RE: Civil Engineering Design Review and Flood Impact Assessment Certification for Norman Griffith Oval Refurbishment.

Appendix A – Flood Impact Assessment and Stormwater Detention System Review Report

Detailed Flood Impact
Assessment and independent
sign off

Norman Griffiths Oval Upgrade Works

Overland Flow Path Capacity

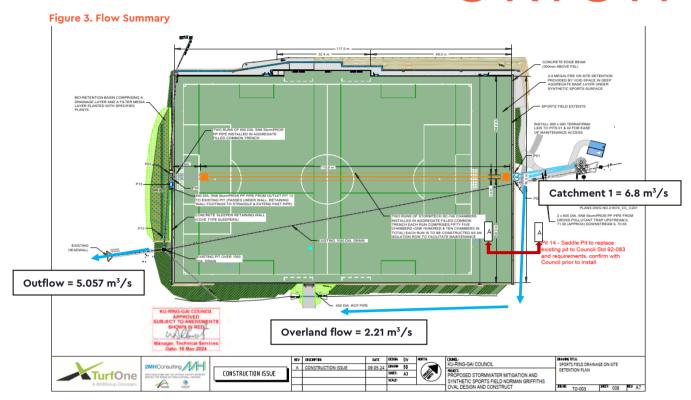
The overland flow path diverted around the eastern and southern perimeter of the oval requires 2.41m³/s of overland flow capacity without overtopping the proposed and partially constructed concrete plinth structure.

We note the required cross-sectional area of the overland flow path is 1.2m² at a slope of 0.5% and velocity of 1.84m/s to safely convey these flows. Please see the recommended options provided in the section below which allows for conveyance of the 2.21m³/s of overland flow.

Figure 8 - Modified eastern paths to provide overland flow capacity

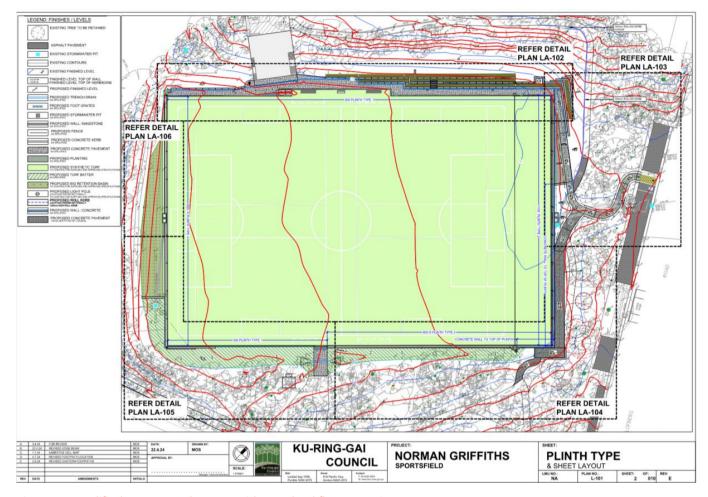
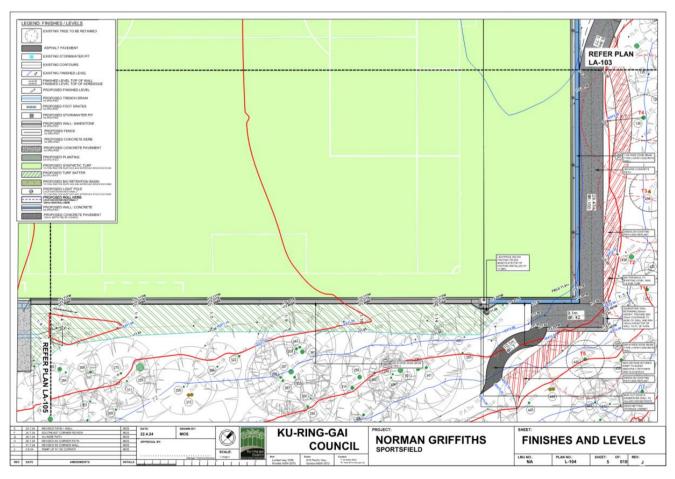
- a. the 3m wide concrete pathway specified at the levels specified is constructed in accordance with our markups to ensure sufficient capacity is provided for the overflow occurring in this flood event.

- 4. the 3m wide concrete pathway specified at the levels specified is constructed in accordance with our markups to ensure sufficient capacity is provided for the overflow occurring in this flood event.
- 5. The diversion wall is constructed to the top of wall levels we have specified
- 6. The drainage at the base of the bleachers is installed and maintained
- 7. Our concerns with the settlement risk of the field drainage media are addressed by the addition of a bidim later between the detention storage rockfill and the bedding layer for the shockpad and playing surface to limit settlement of the playing surface via material loss from the bedding layer into the detention storage layer.

DRAWING TITLE:
STORMWATER LONG SECTIONS & PIT
SCHEDULE SHEET 1

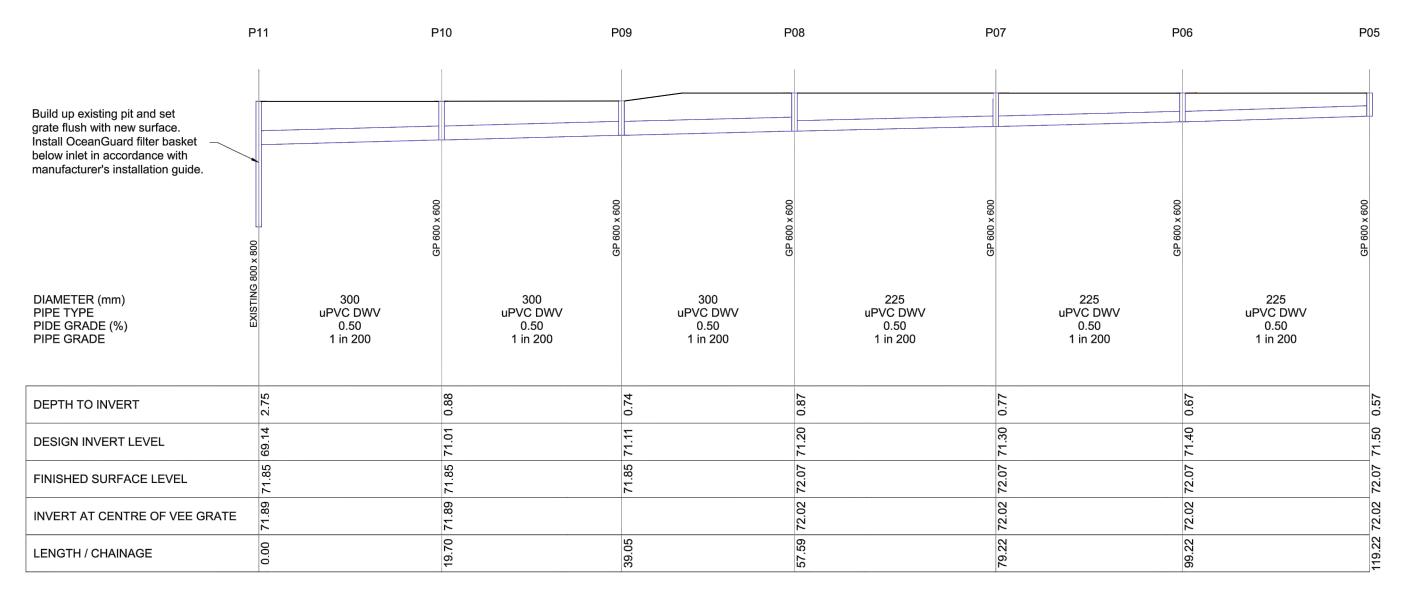
Pit 14 - Saddle Pit to replace existing pit to Council Std 92-083 and requirements, confirm with Council prior to install KU-RING-GAI COUNCIL APPROVED SUBJECT TO AMENDMENTS SHOWN IN RED

Pit heights to match revised path & grated drain design design. Levels may alter slightly on-site to suit

SECTIONAL VIEW OF STORMTECH TRENCH AT CH 1.0

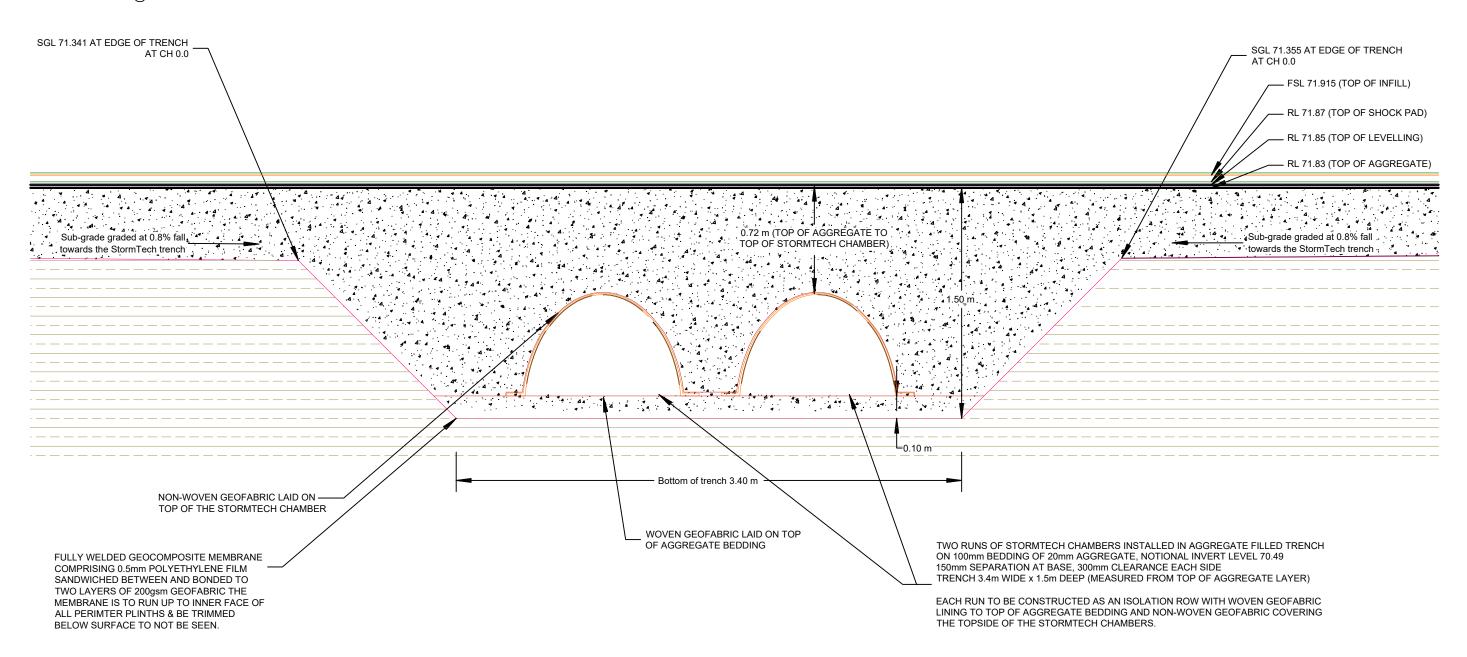
Query still unanswered on the 100mm beneath the chambers - to confirm prior to install

SECTION J

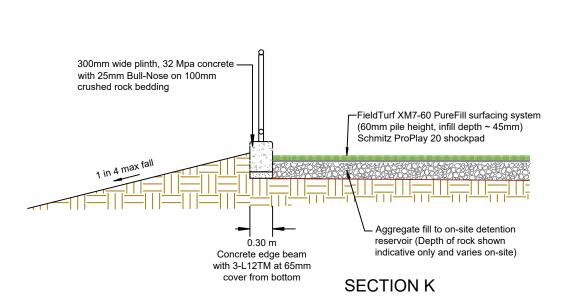
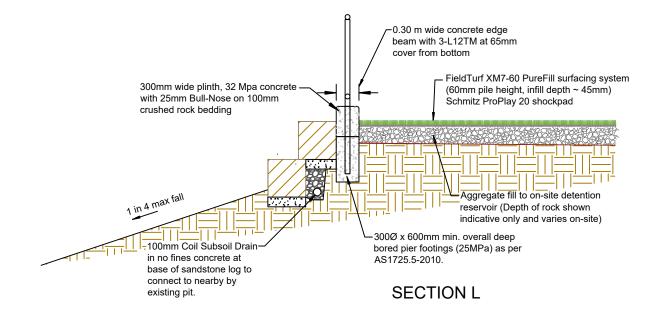
Will be unable to be built as shown below - levels/requirments of overland flow path to be met 6.0m High Soft Mesh Netting 1x 500mm high sandstone blocks on 800mm wide, 400mm deep concrete plinth on 100mm crushed rock bedding. Plinth to have sl82 mesh at 65mm cover from -1.1m High Fence FieldTurf XM7-60 PureFill surfacing system FSL 72.5 top plinth 2.8m approx width to invert (60mm pile height, infill depth ~ 45mm) FSL 72.21 Schmitz ProPlay 20 shockpad (width varies) Aggregate fill to on-site detention reservoir (Depth of rock shown indicative only and Blocks to be binded to plinth -0.80 m with mortar or suitable product varies on-site) Concrete edge beam to reduce water ingress. with sl82 mesh at 65mm cover from bottom

SUBJECT TO AMENDMENTS Couincil have provided a structural engineer review. Confirmation required to points raised in email titled 'RE:NG - Strcutral Certification' sent 9:08am 17/5/24

DRAWING TITLE: ORTS FIELD SECTION DETAILS SHEET 6

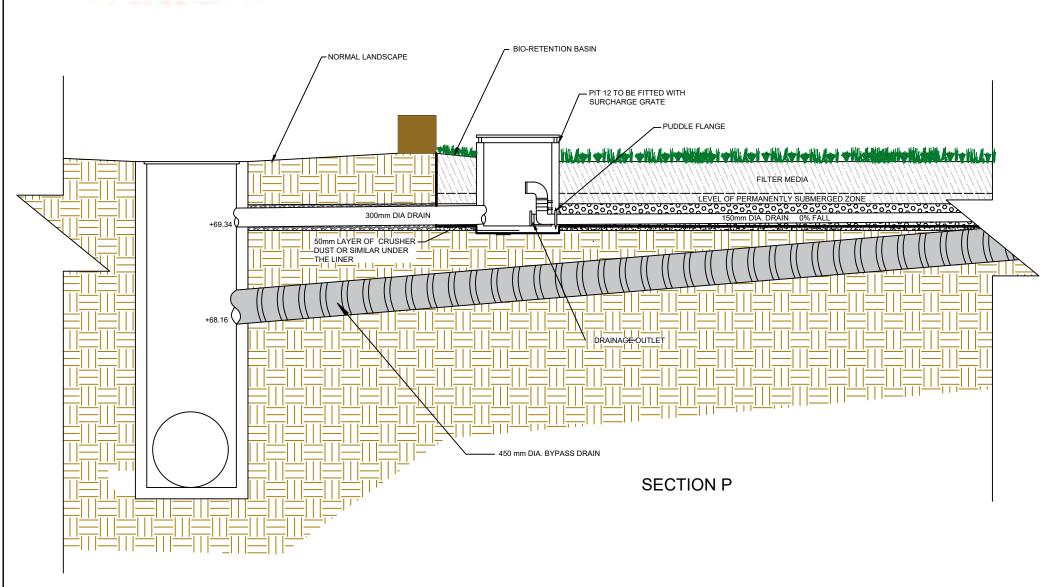
Environmental Engineer to provide final sign-off to Bio-Basin works

PATH CROSS SECTIONS
SHEET 1

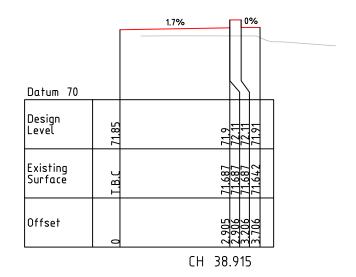
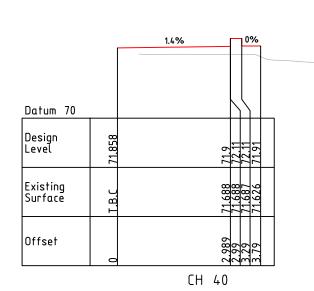
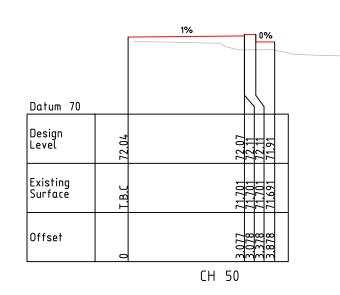
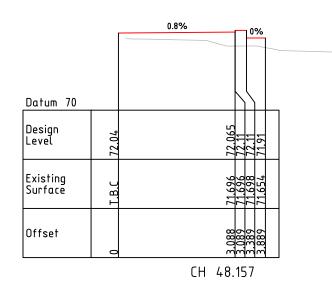
Levels have not been checked to confirm they meet levels provided by Council. Refer to Ku-ring-gai Council Finishes and Levels Plans

TYPICAL RETAINING WALL DETAILS						
RETAINING HEIGHT	UPRIGHT SIZE	FOOTING DEPTH				
1000mm - 1600mm	150 UC 37 @ 2030mm MAX. CTRS.	450mm DIA. x 2500mm MIN. O/A DEEP, OR FOUNDED 1000mm MIN. INTO SANDSTONE ROCK.

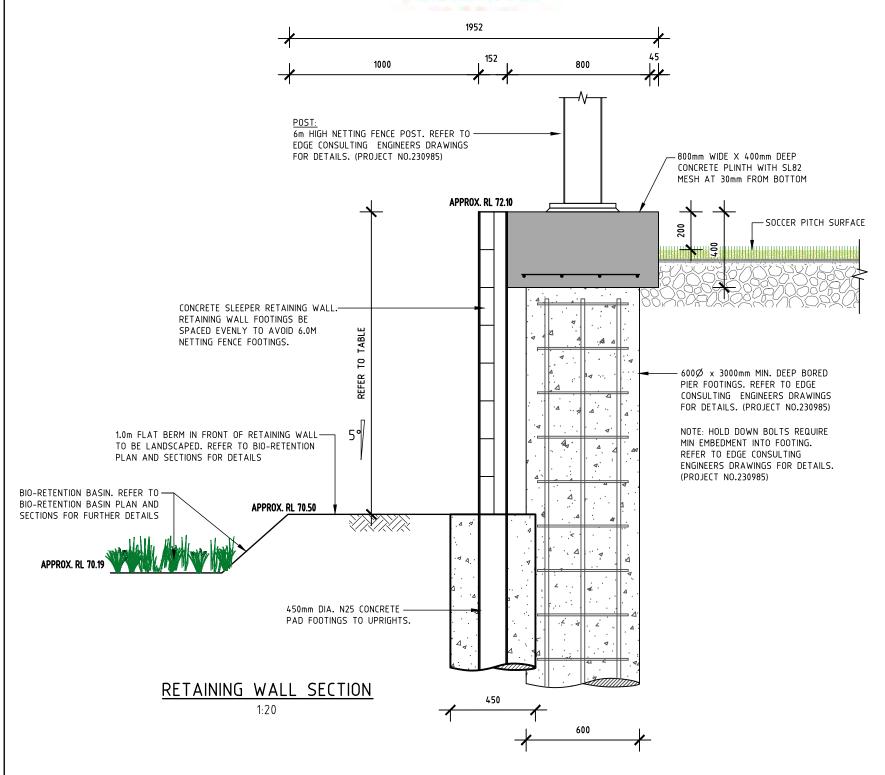
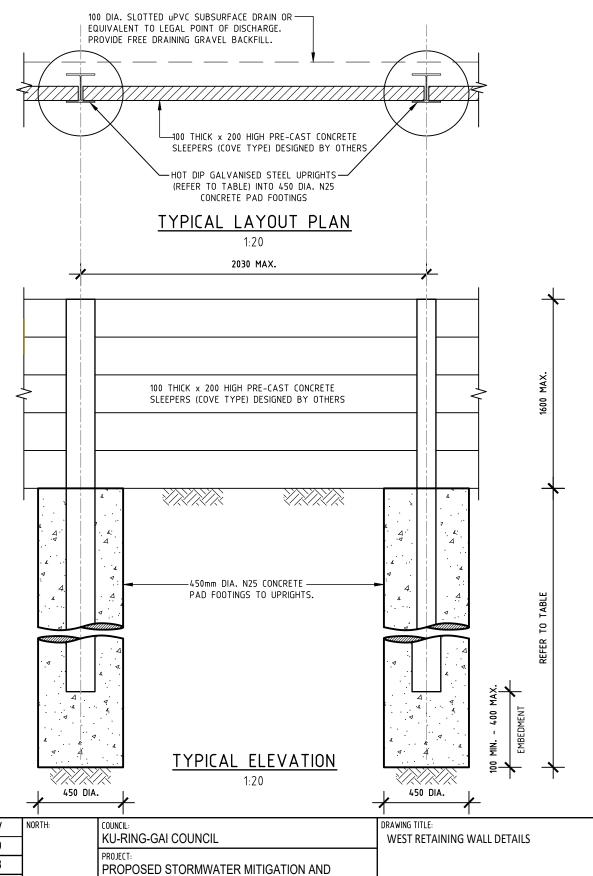
Still errors on this page as per previous markups
